CONVAIR

COMMERCIAL CHANGE PROPOSAL

CUSTOMER Swissair Transport Co., Ltd.

MODEL: 30-6 (Convair "990")

Page 7a
Report No. ZD-30-013
Model 30

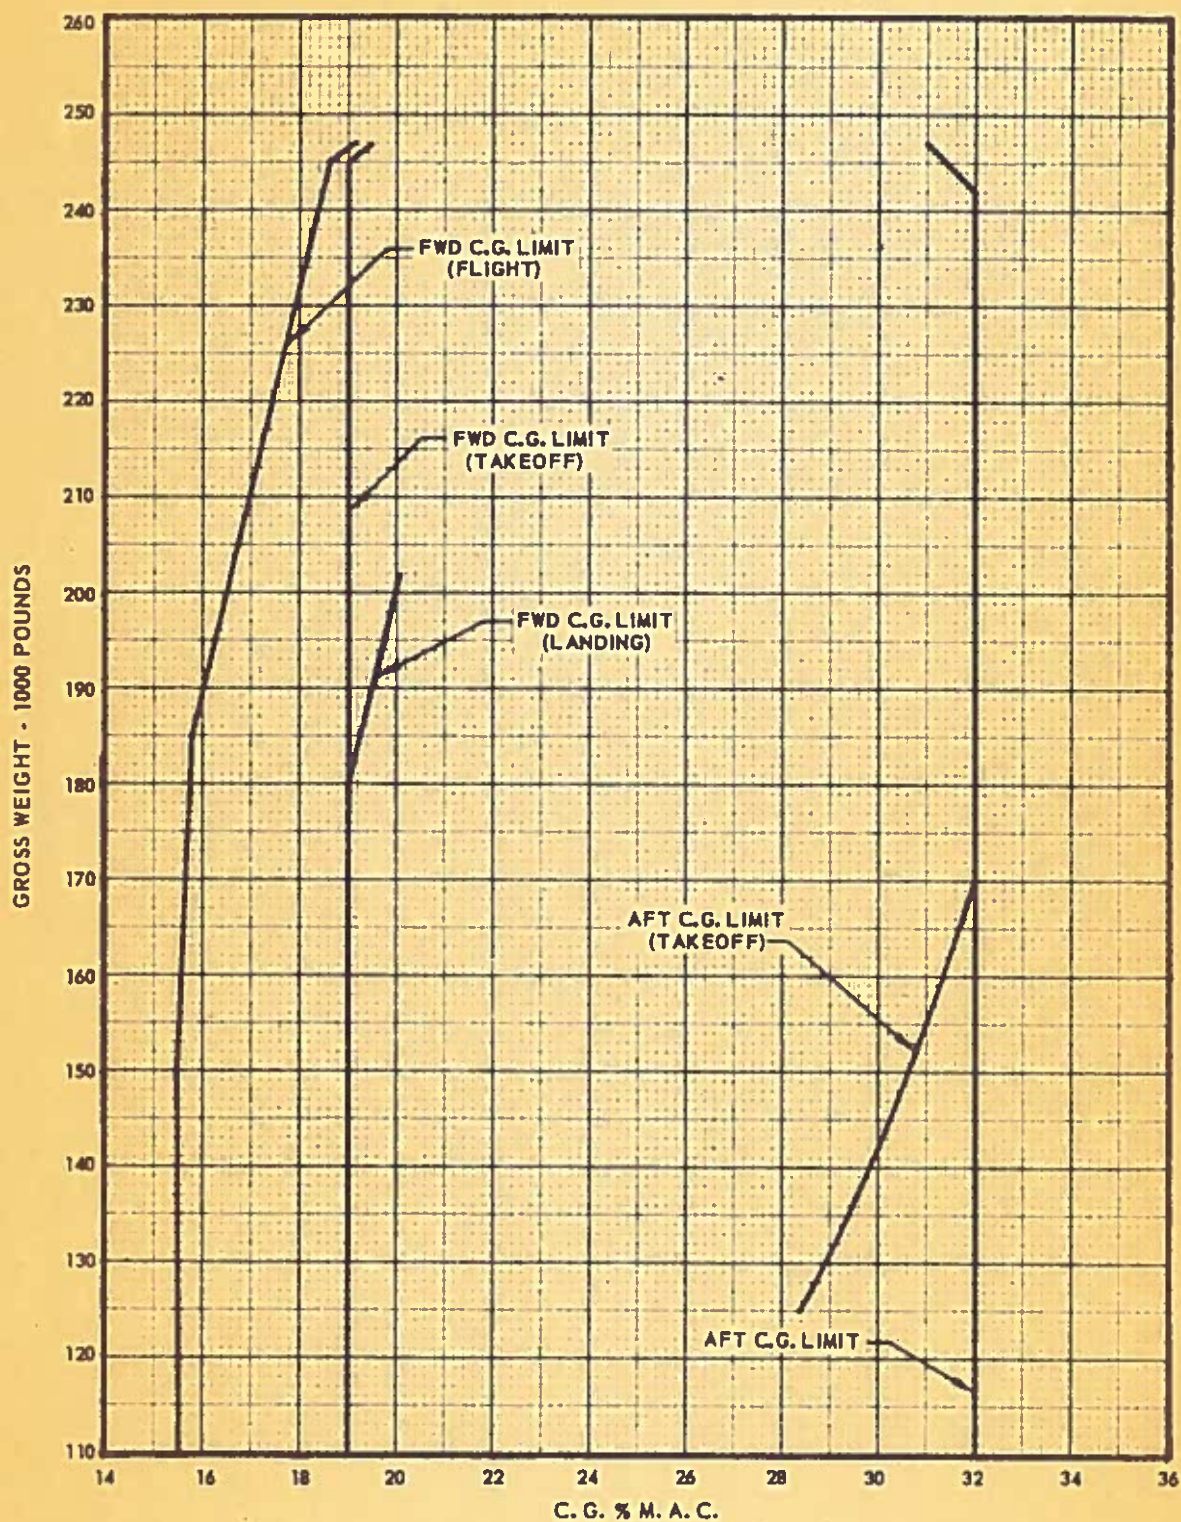
Revise the above illustration to show affects of this change.

Change the following item in the paragraph:

Enclosure: (A) One copy Page 7a - C.G.Limits Illustration (Revised)

Enclosure: (A) One copy Page 74a - PILOT'S AND COPILOT'S INSTRUMENT
PANELS (Revised)

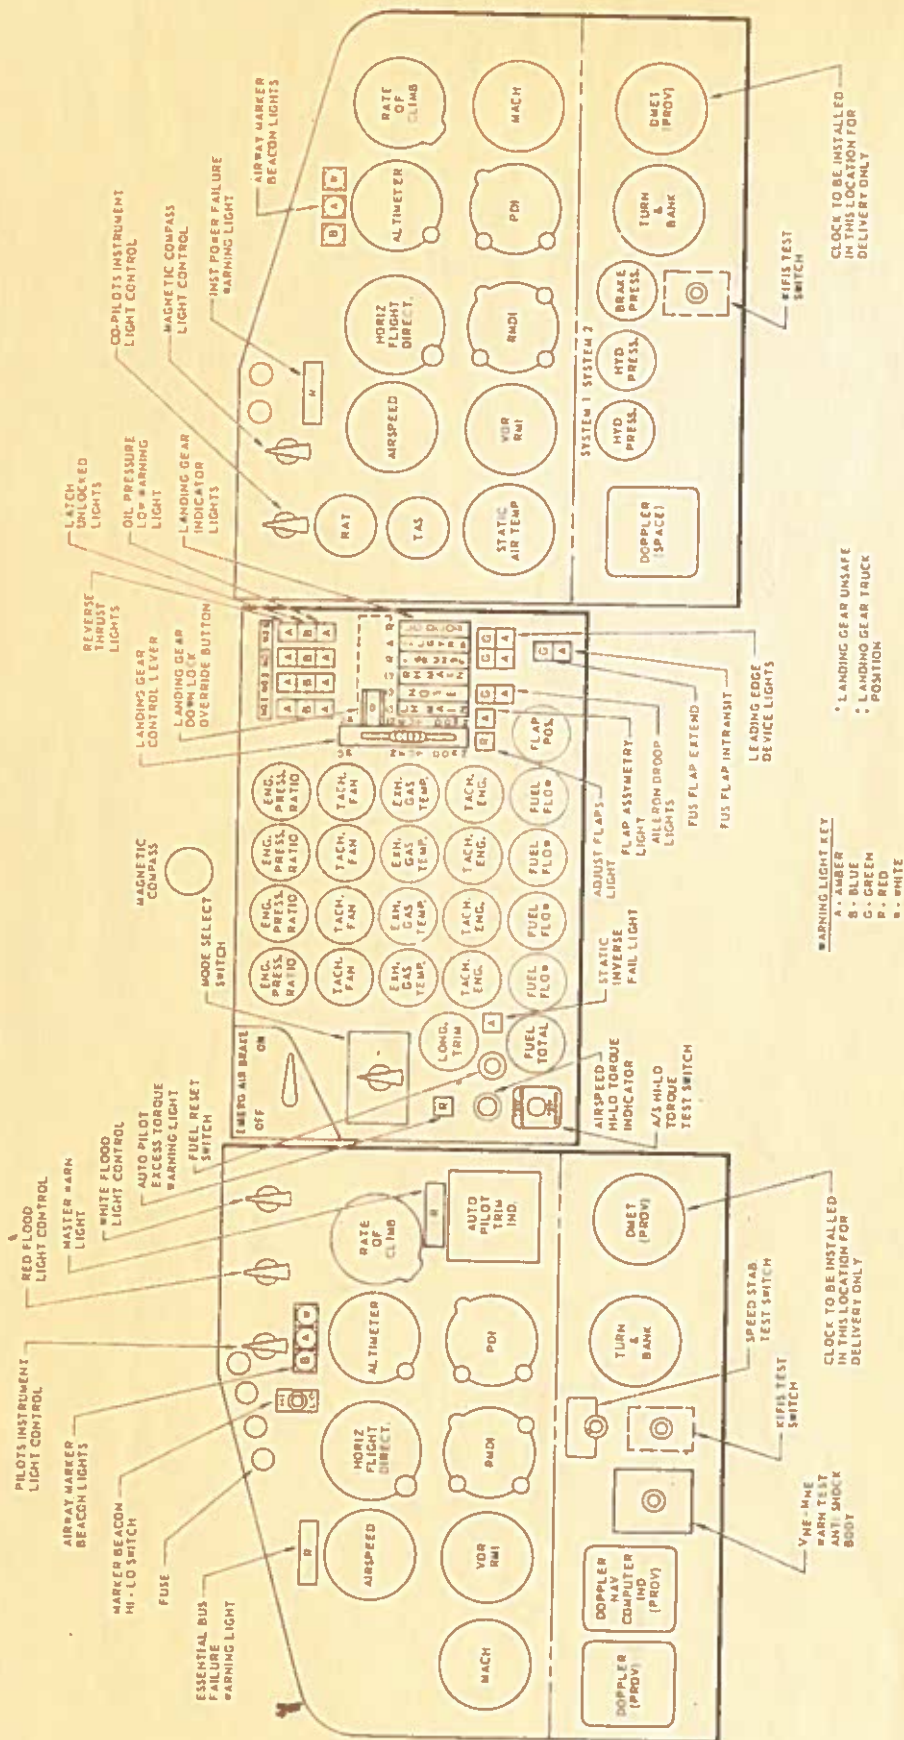
Replace the above illustration in the specification with Enclo-
sure (A) which shows the subject switch.

Enclosure: (A) One copy of Page 50a - PITOT STATIC SYSTEM (Revised)

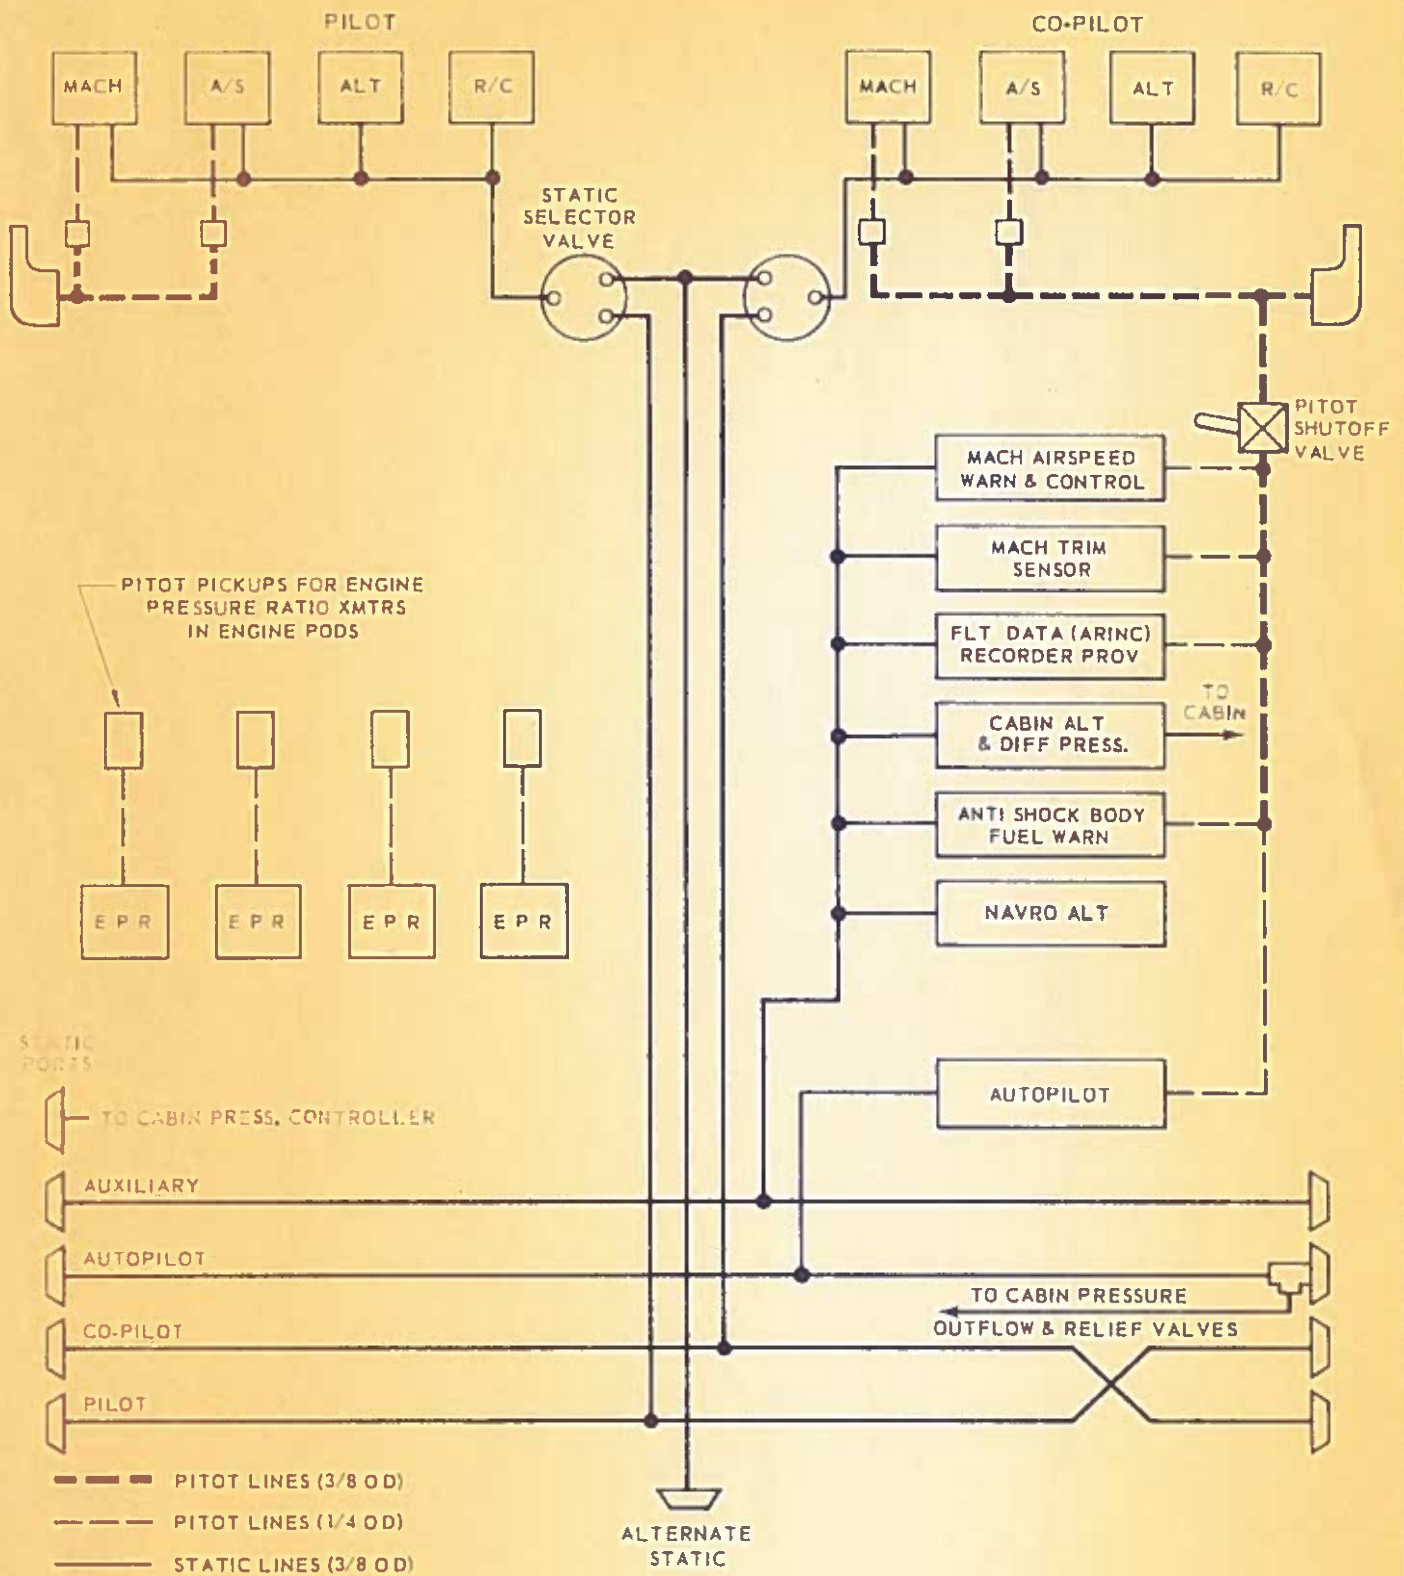
Reason for Change: To up-date the pitot static system illustration and to show individual EPR probes and separation of static sources for cabin outflow valves and cabin controller for reliability; and revision to CCP No. 124.

Replace above illustration in specification with Enclosure (A) which is revised to show current changes.

Enclosure: (A) One copy of Page 111a - ESTIMATED CABIN PRESSURE
SCHEDULE (Revised)

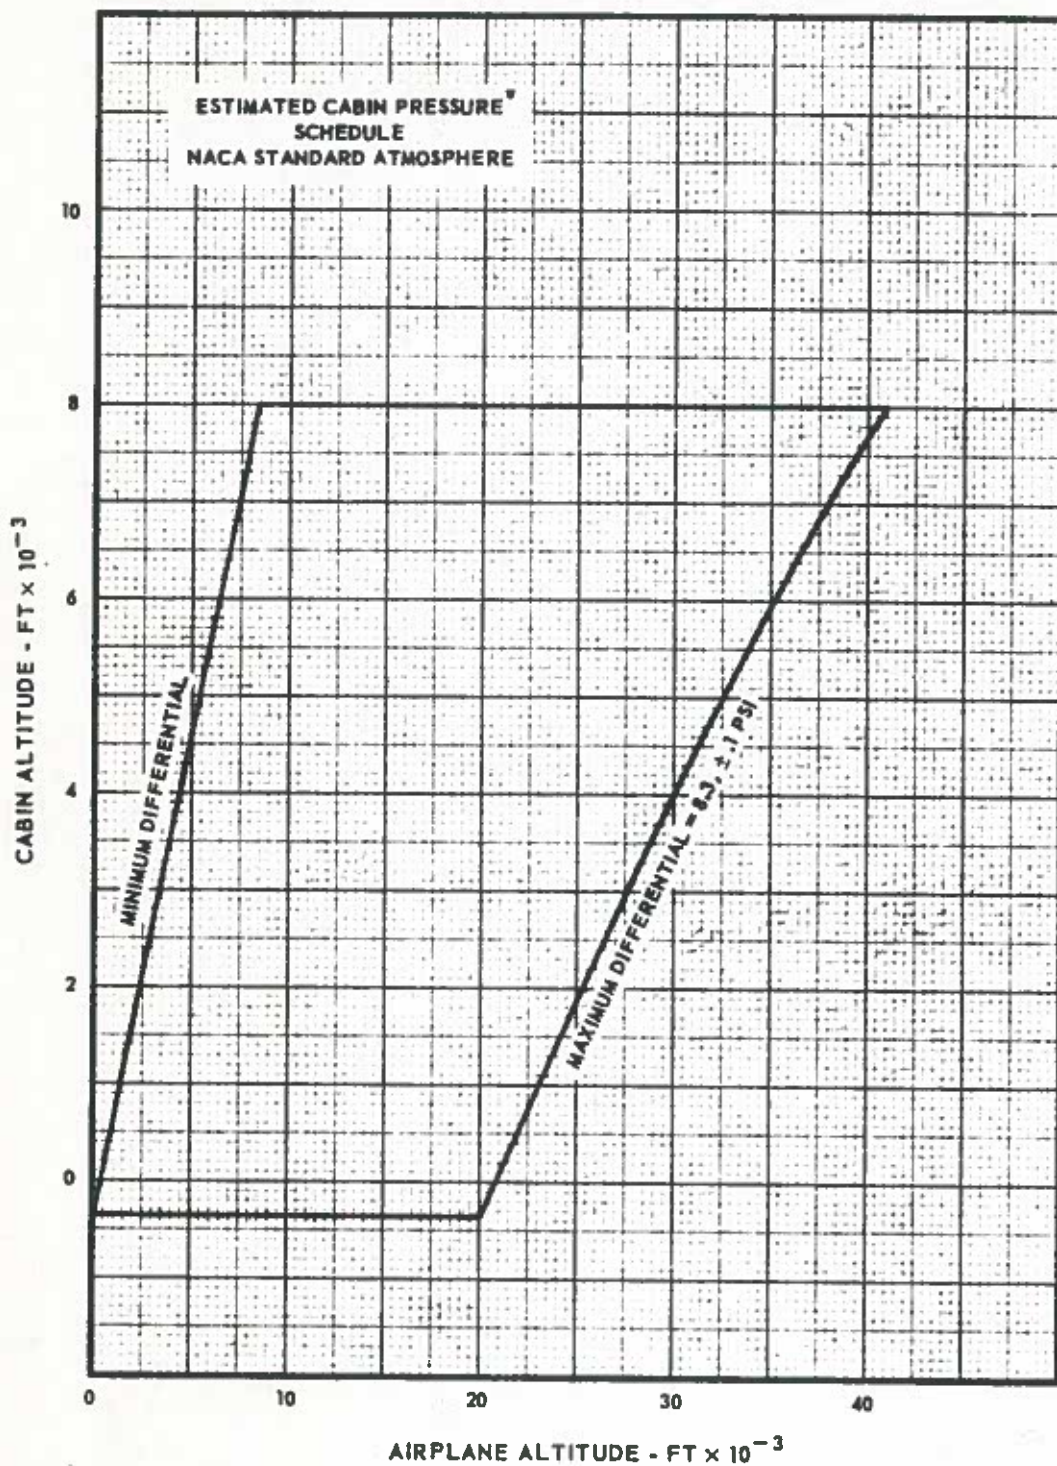
The above illustration shall be revised to show effect of this change.

Enclosure: (A) One copy Page 48d - FIRE CONTROL PANEL (Revised)

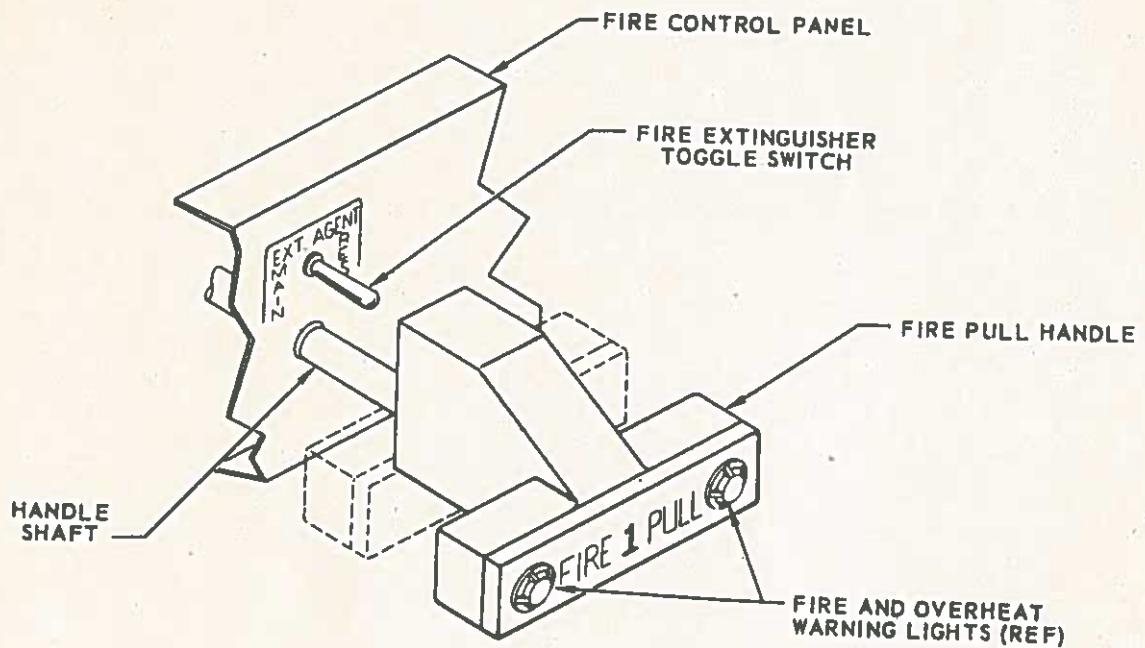
Reason for Change: 1. To provide latest current Fire Control Panel illustration which includes wheel well indicator lights.

Replace the above illustration in the specification with Enclosure (A).

Enclosure: (B) One copy Page 71a - WARNING HORN DIAGRAM (Revised)

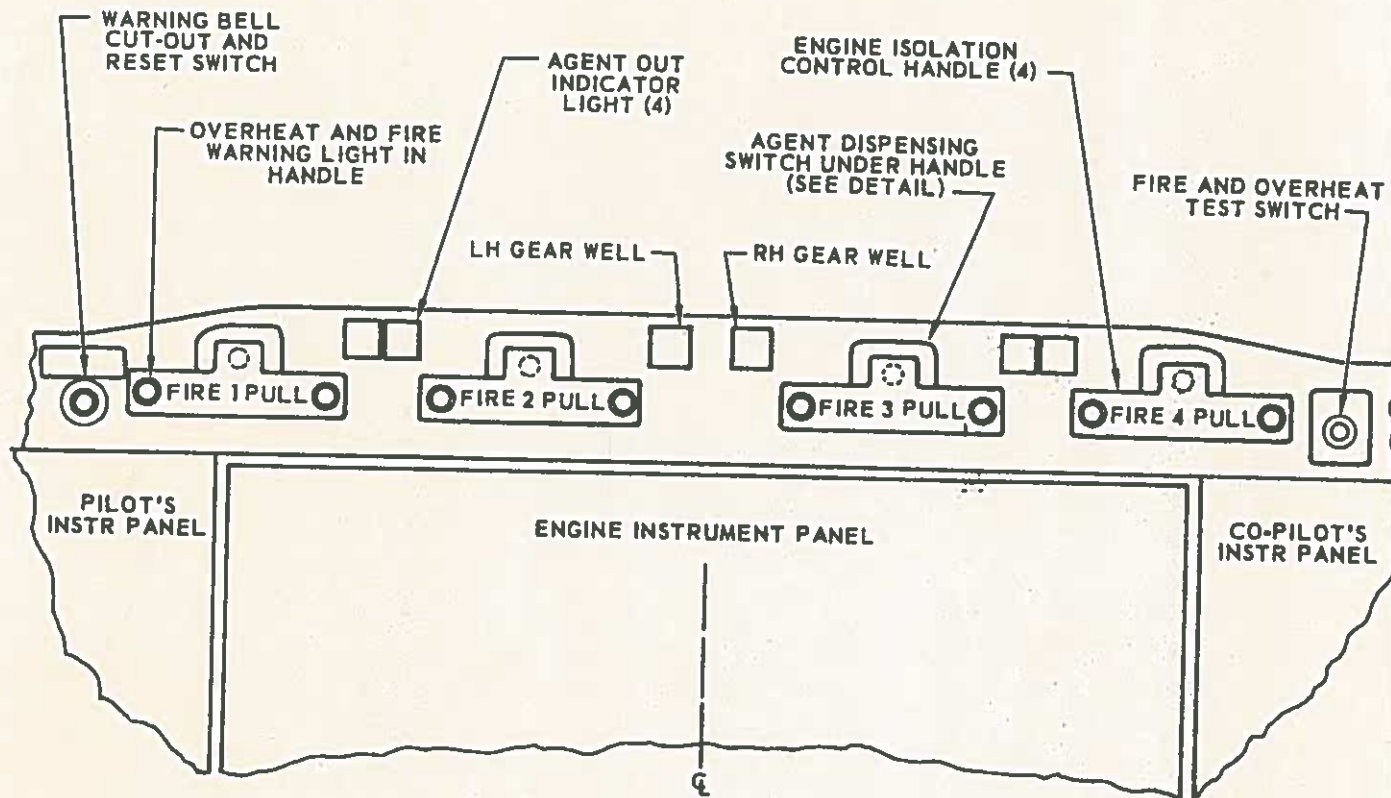
2. To provide Warning Horn illustration which includes all warning circuits, to make consistent with the actual installation.

Replace the above illustration in the specification with Enclosure (B).

Enclosure: (A) One copy Page 99a - FIRE EXTINGUISHING SYSTEMS (Revised)

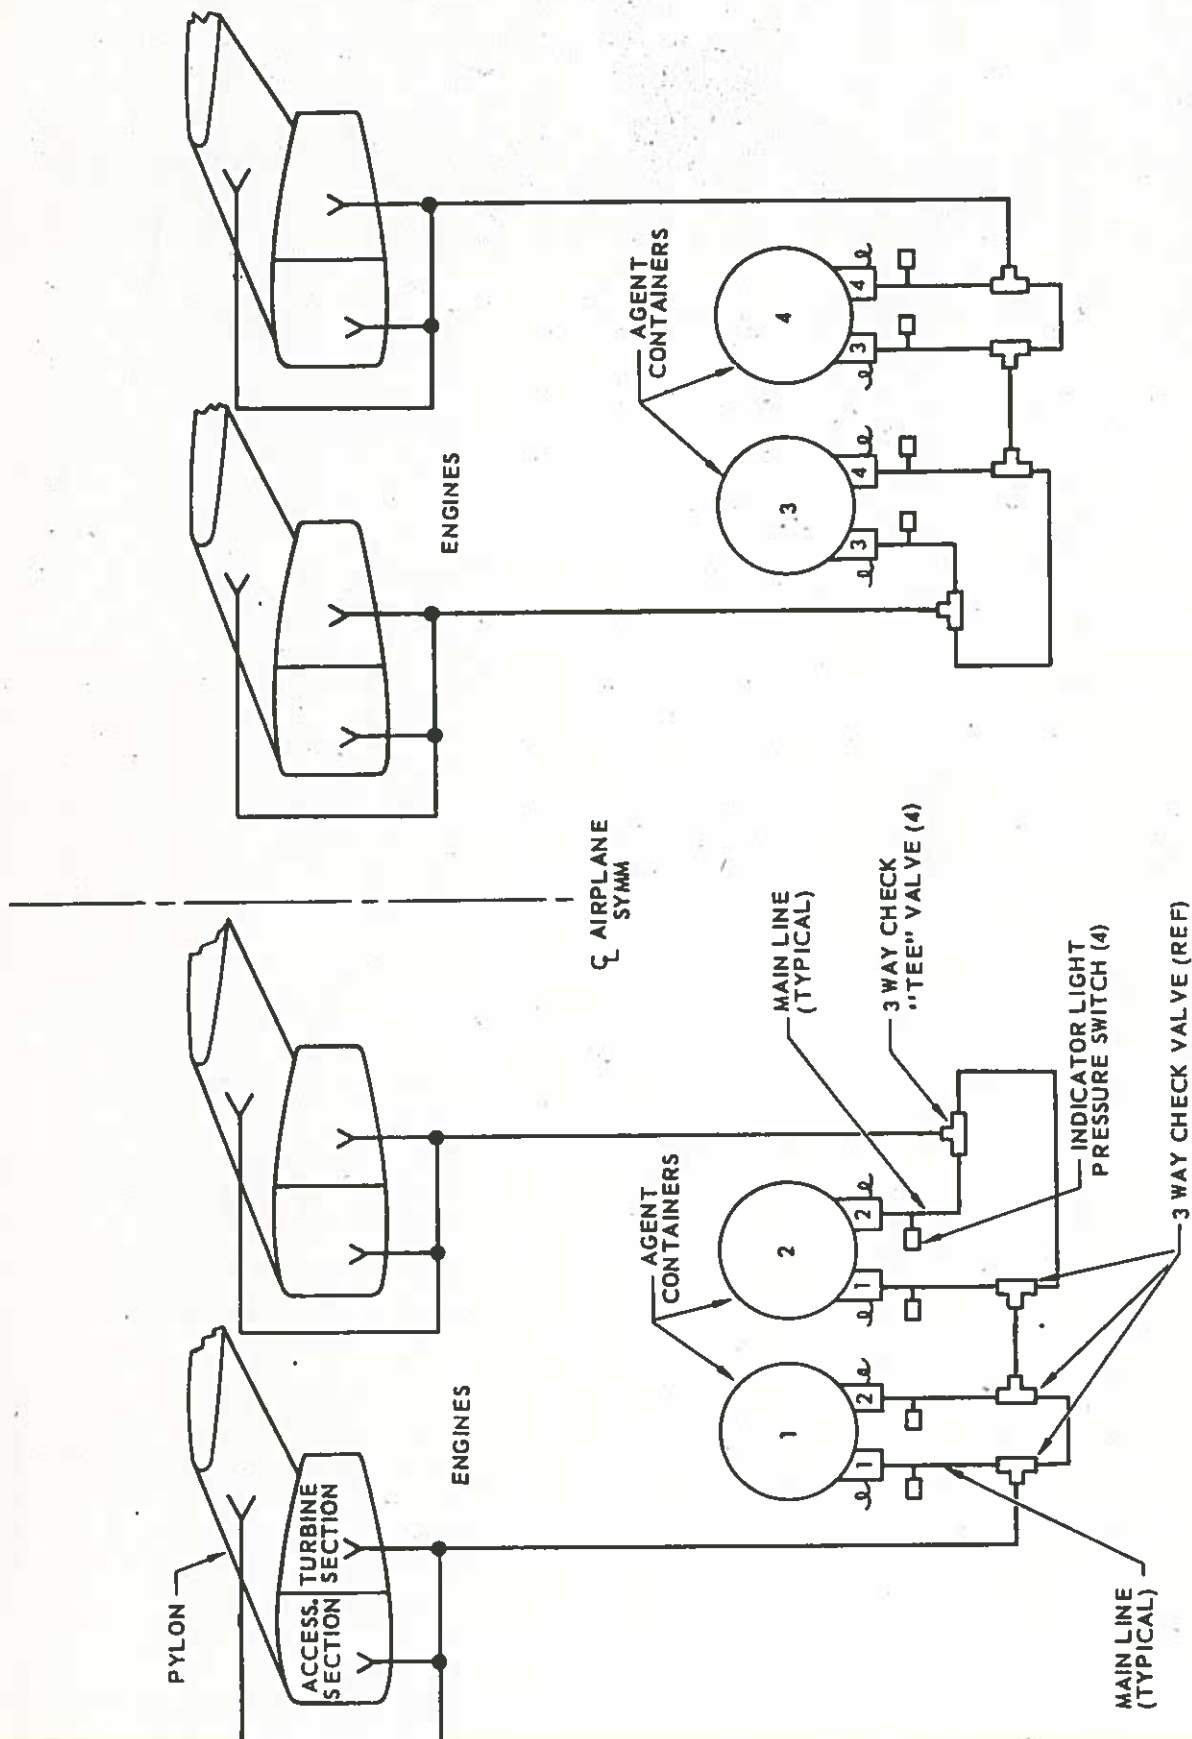
Reason for Change: To standardize subject illustration for all Model 30 aircraft, to avoid misinterpretation of letter and arrow coding of three-way check valves.

Replace the above illustration in the specification with Enclosure (A), which is proposed as the standard illustration for Model 30 Fire Extinguishing Systems.
